**Re: Comments on the Environmental Review conducted for
the Kongsgaard Wine LLC – Atlas Peak Vineyard
Conversion: Agricultural Erosion Control Plan (ECPA)
#P14-00069-ECPA**

Subject: Review of IS/MND
Kongsgaard Wine LLC – Atlas Peak Vineyard Conversion
Agricultural Erosion Control Plan #P14-00069

FIGURE 1: County designated MST groundwater basin (Source: Napa County Groundwater Ordinance).

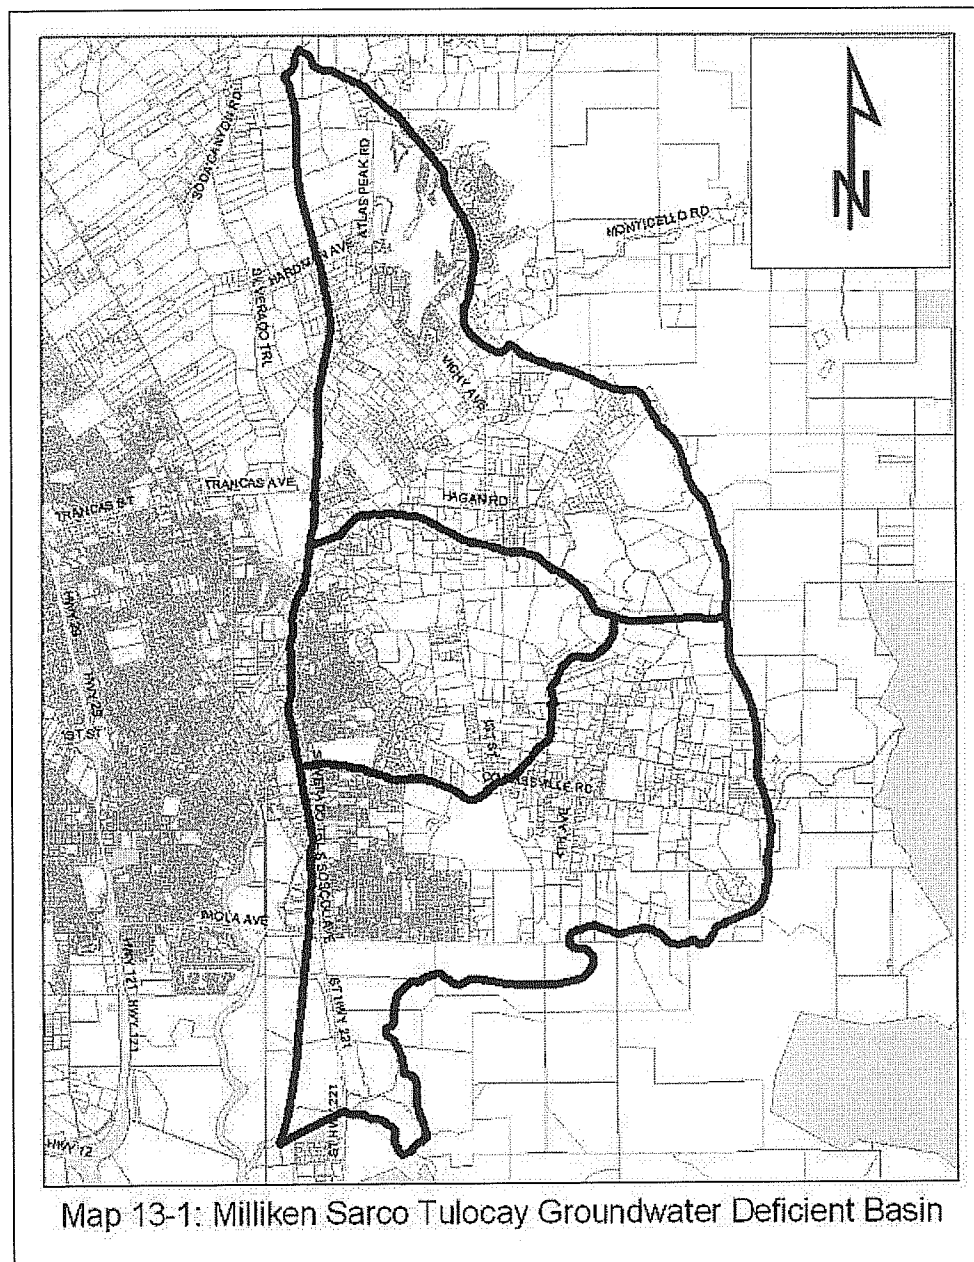
The County delineates the MST basin as indicated in Figure 1 (Napa County Ordinance No. 1294, Chapter 13.15 Groundwater Conservation). The County's MST delineation likely comes from the "Study Area" designation presented in the 1977 USGS report (Johnson, 1977) cited in the WAA. The "Study Area" outlined in 1977 USGS report defines the downstream alluvial aquifer and underlying Sonoma Volcanic groundwater storage areas associated with known groundwater overdraft. This "Study Area" encompasses a 15-square mile area within the cumulative 42-square mile drainage area for the Milliken, Sarco and Tulucay Creek watersheds (see Figure 2). The point of this discussion is to distinguish between the County's jurisdictional MST "Study Area" and the physically-based MST hydrologic watershed and groundwater system.

FIGURE 2: Location of 2003 USGS study area, differentiating between basin drainage area and “Study Area” boundaries (Source: Figure 1 in Farrar and Metzger, 2003).

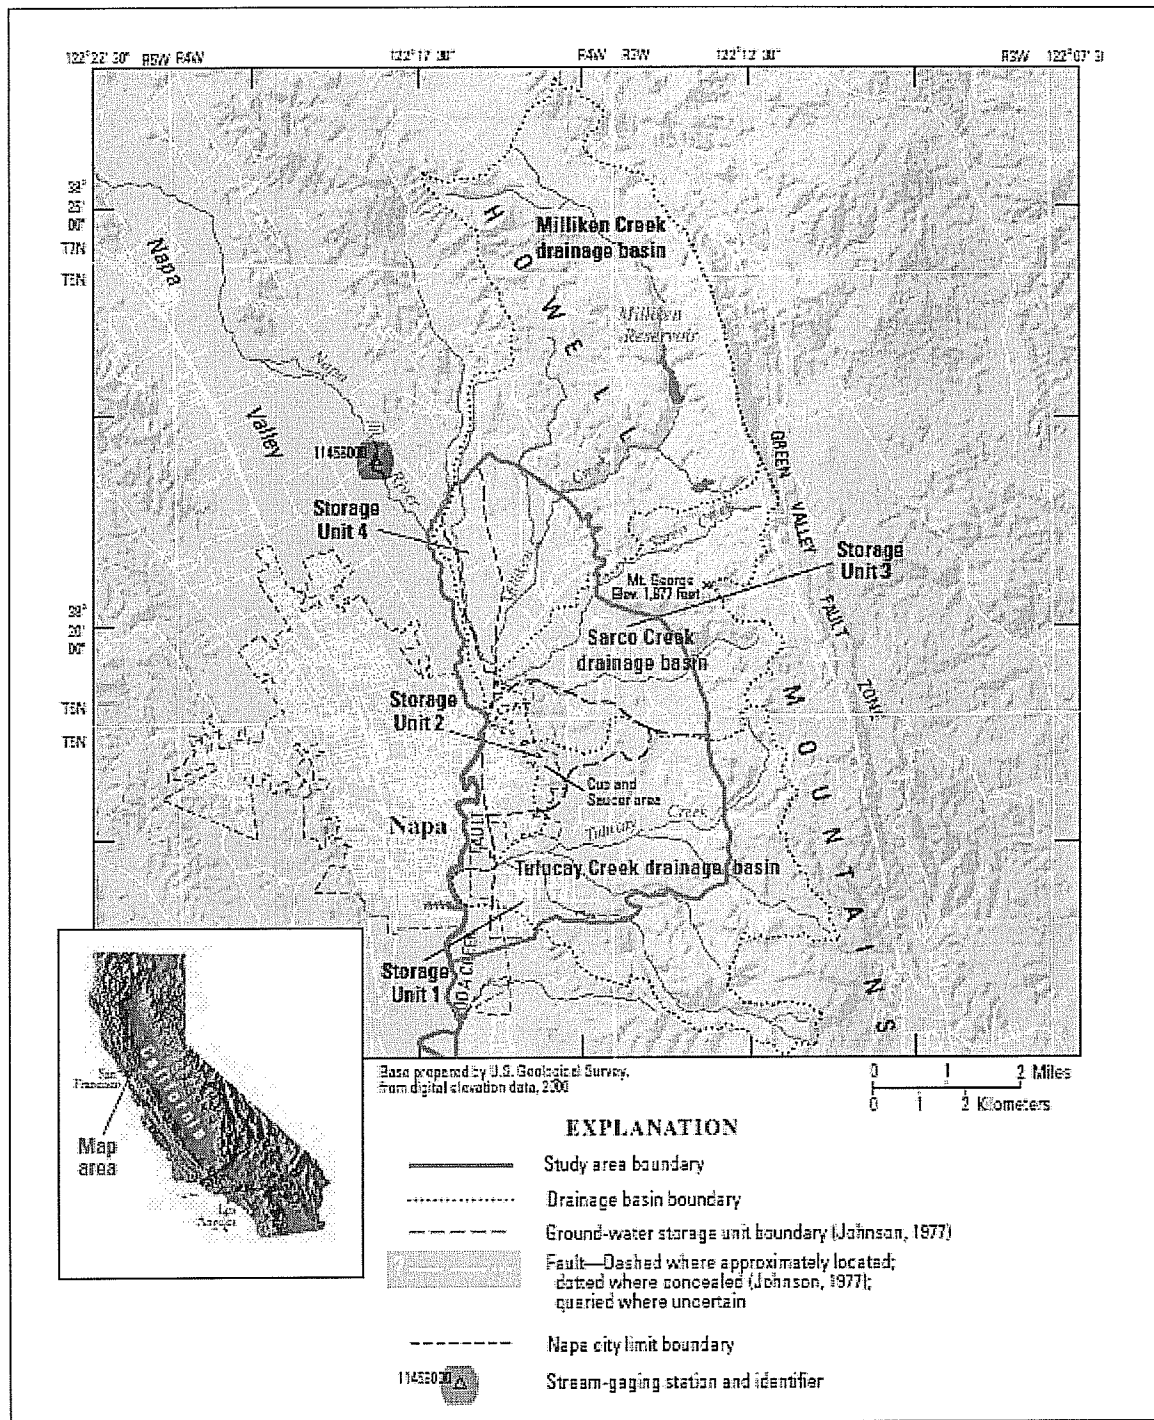
The 1977 USGS study, along with the more recent follow-up study completed by the USGS (Farrar and Metzger, 2003) clearly indicate that the 27-square mile higher elevation bedrock area lying to the east (and including a portion of the Project area) are in direct hydraulic connection with and provide recharge to the 15-square mile MST groundwater storage "Study Area." The USGS (2013) provides a graphical representation of the groundwater system underlying the MST Creeks watershed, reproduced here in Figure 3. This conceptual groundwater flow model indicates that rainfall infiltrates and recharges the Sonoma Volcanic bedrock groundwater in the eastern uplands up to the topographic drainage divide. The groundwater in the Sonoma Volcanic bedrock then migrates westward over time towards the main alluvium and deeper Sonoma Volcanics storage area in the valley bottom, adjacent to the Napa River (designated "Study Area"). The eastern boundary of the County's designated MST basin generally occurs where the foot of the mountains intersect the valley floor. In reference to the MST basin, Farrar and Metzger (2003, page 59) state, *"The principal source of ground-water replenishment to the study area is lateral flow of ground water that is recharged in the Howell Mountains to the east of the study area."* They also state (2003, page 21), *"Johnson (1977) estimated that the average annual recharge in the area of this study in 1975 was 5,400 acre-ft/yr: 3,050 acre-ft/yr from streamflow infiltration; 2,100 acre-ft/yr from subsurface inflow from the Howell Mountain block; and about 250 acre-ft/yr from direct infiltration of precipitation."*

FIGURE 3: Conceptual model of groundwater flow system in the lower Milliken-Sarco-Tuluca Creek area (Source: Figure 9 in Farrar and Metzger, 2003).

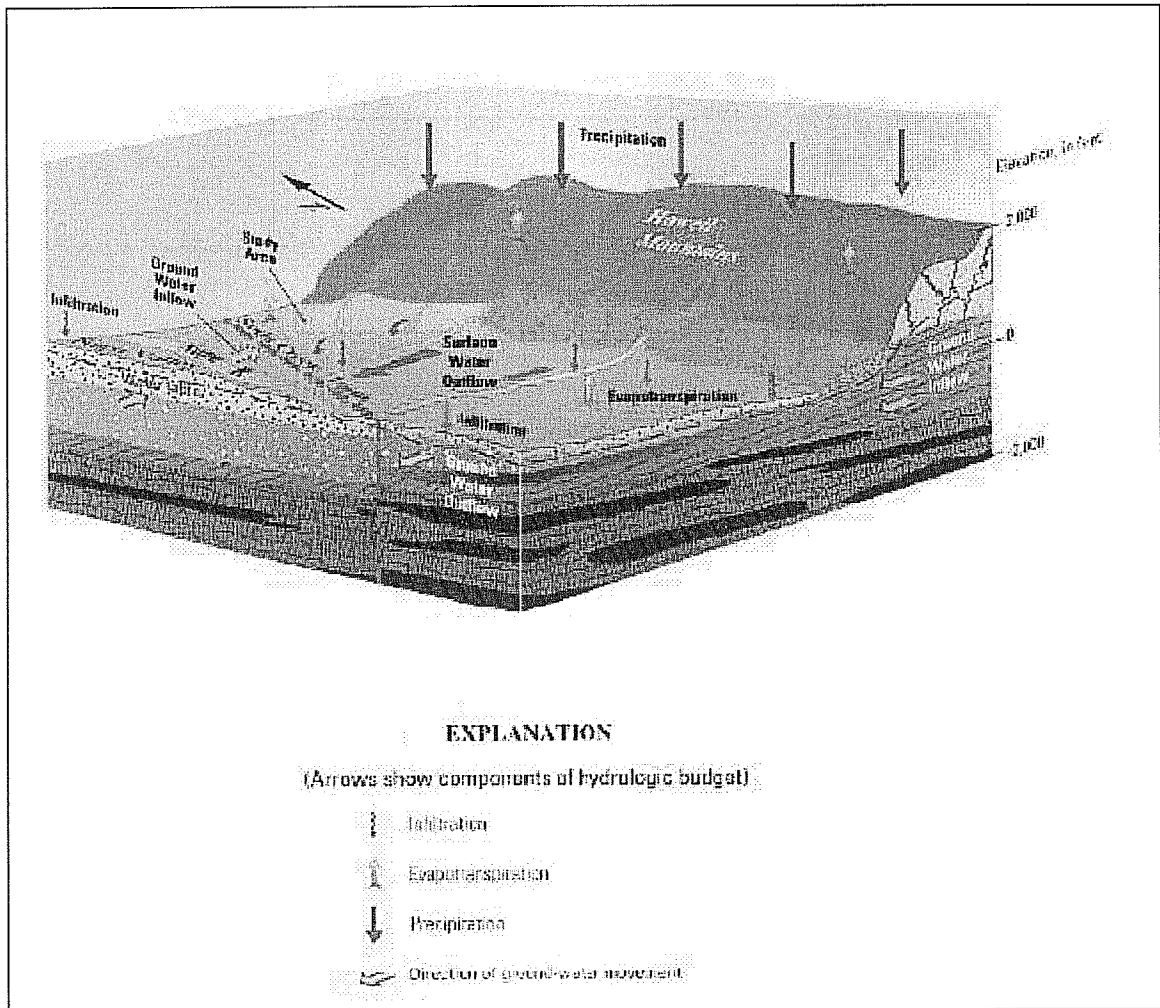
I believe that the 1977 and 2003 USGS studies provide conclusive information that the portion of the project area underlain by Sonoma Volcanics and draining to Milliken Creek lies in an important recharge area to the MST groundwater basin and is hydraulically connected to the lower MST groundwater storage area. Thus, any withdrawals from the Sonoma Volcanics within the Project site will directly reduce the groundwater inflow and supply to the MST basin and further deplete groundwater resources in an already groundwater deficient basin.
